**Project: IEEE P802.15 Working Group for Wireless Personal Area Networks (WPANs)**

**Submission Title:** [Comment resolution related to Annex F in D6]

**Abstract:** [This document describes the comment resolution related to Annex F in D6]

**Purpose:** [To resolve the comments related to Annex F in D6 after the SB 1<sup>st</sup> recirculation ]

Figure F.4—Typical Si photo-detector wavelength sensitivity

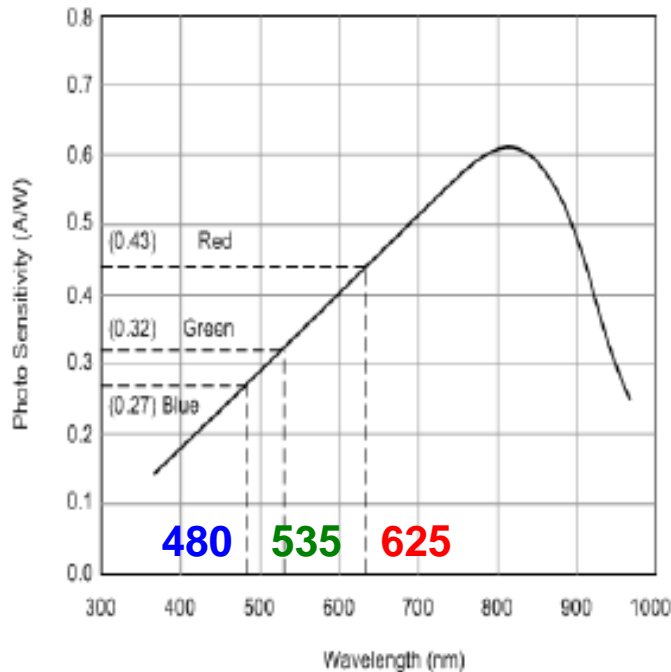
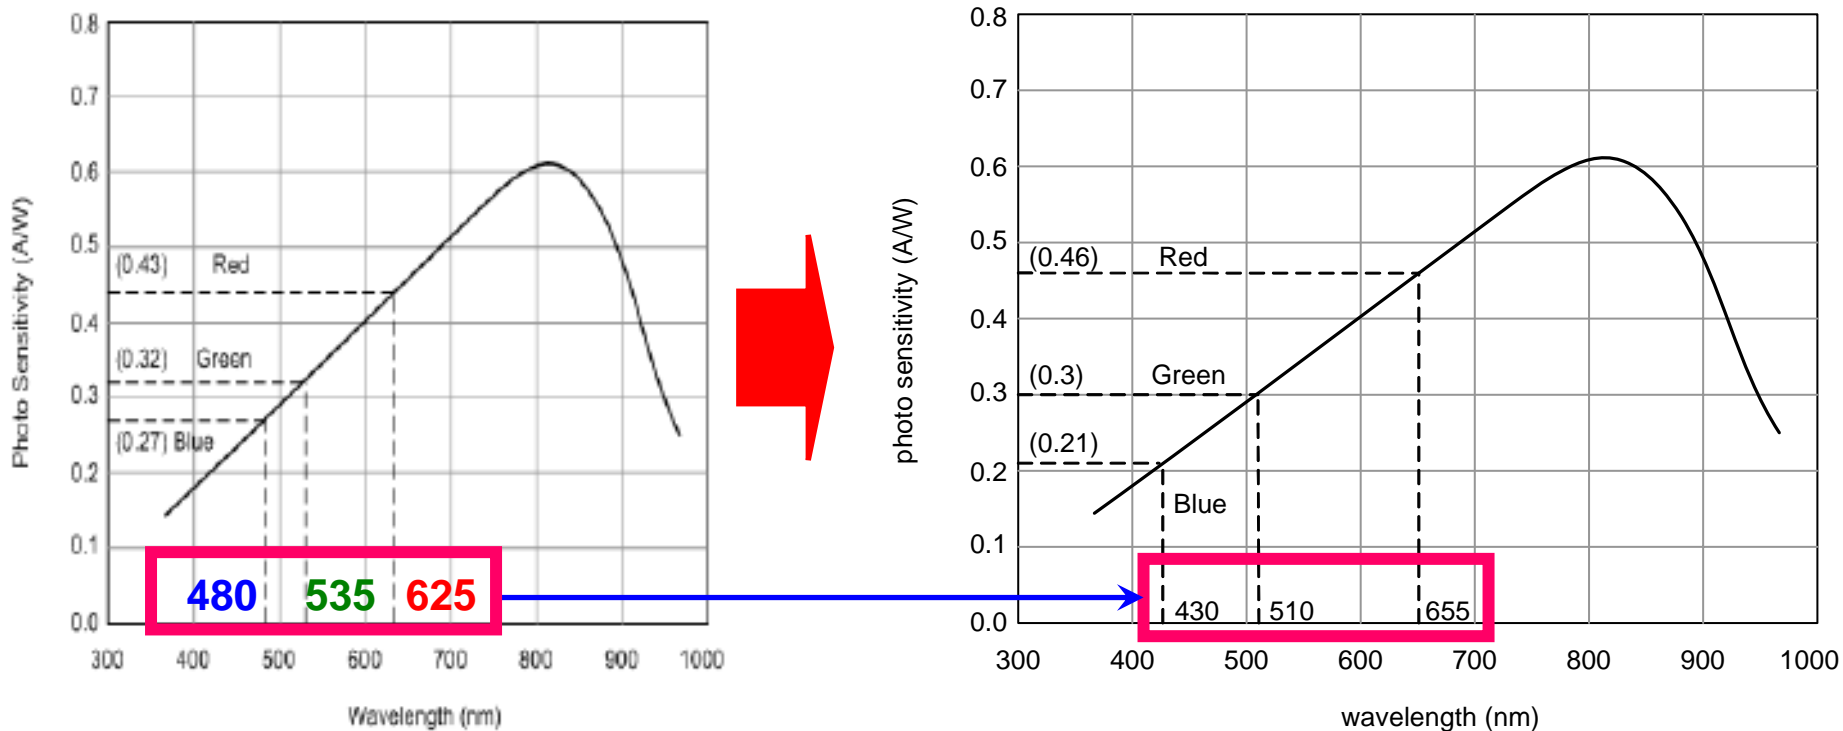
Comment No.	Name	Page	Subclause	Line	Comment	Proposed Change
21	Lim, Sang-Kyu	281	Annex F	36	Table F.1	Remake the Table F.1 as per the updated bandplan.
22	Lim, Sang-Kyu	282	Annex F	45	Table F.2	Remake the Table F.2 as per the updated bandplan.
23	Lim, Sang-Kyu	282	Annex F	40	Figure F.4	Redraw the Figure F.4 as per the updated bandplan and the updated Table F.2.
24	Lim, Sang-Kyu	282	Annex F	11	According to the updated band plan in Table 75 (page 213), 480nm, 535nm, and 625nm are not center wavelengths in 7 color bands any longer.	Change "480nm, 535nm, and 625nm" to the center wavelengths in the updated 7 color bands.

- **Figure F.4 and 1<sup>st</sup> paragraph on page 282**

Figure F.4 shows the photo sensitivity characteristics of a Si photo-detector according to the wavelength variation. It has been known that the photo sensitivity value of Si photo-detector is higher on longer wavelength than on shorter wavelength in the visible band as shown in Figure F.4. Figure F.4 shows that a Si photo-detector produce more electrical current on red color channel than on green or blue color channel even though the radiometric received powers on each color channel are equal.

- **Figure F.4 should be changed as per the updated Table F.1.**
